PCN Number:	20160602000A	PCN Date:	06/20/2016
Title:	BGA Tray Change		
Customer Contact:	PCN Manager	Dept:	Quality Services
Change Type:			
<input type="checkbox"/> Assembly Site	<input type="checkbox"/> Assembly Process	<input type="checkbox"/> Assembly Materials	
<input type="checkbox"/> Design	<input type="checkbox"/> Electrical Specification	<input type="checkbox"/> Mechanical Specification	
<input type="checkbox"/> Test Site	<input checked="" type="checkbox"/> Packing/Shipping/Labeling	<input type="checkbox"/> Test Process	
<input type="checkbox"/> Wafer Bump Site	<input type="checkbox"/> Wafer Bump Material	<input type="checkbox"/> Wafer Bump Process	
<input type="checkbox"/> Wafer Fab Site	<input type="checkbox"/> Wafer Fab Materials	<input type="checkbox"/> Wafer Fab Process	
	<input type="checkbox"/> Part number change

Description of Change:

Group 1 Device: 9x9mm BGA Tray

Group 2 Device: 10x10mm BGA Tray

TRAY DESIGN CONSIDERATION and COMPARISON

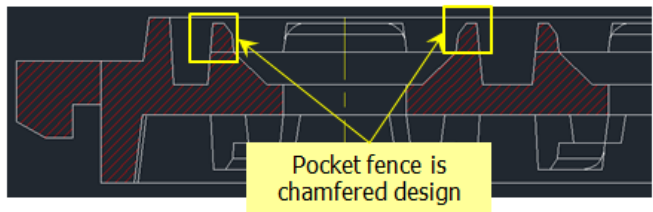
Tray Pocket: Current

Tray Pocket: Proposed

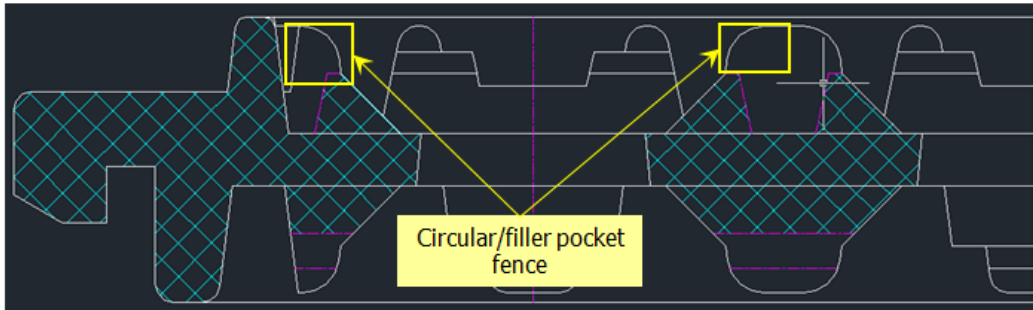
Tray Fence: Current

Tray Pocket: Proposed
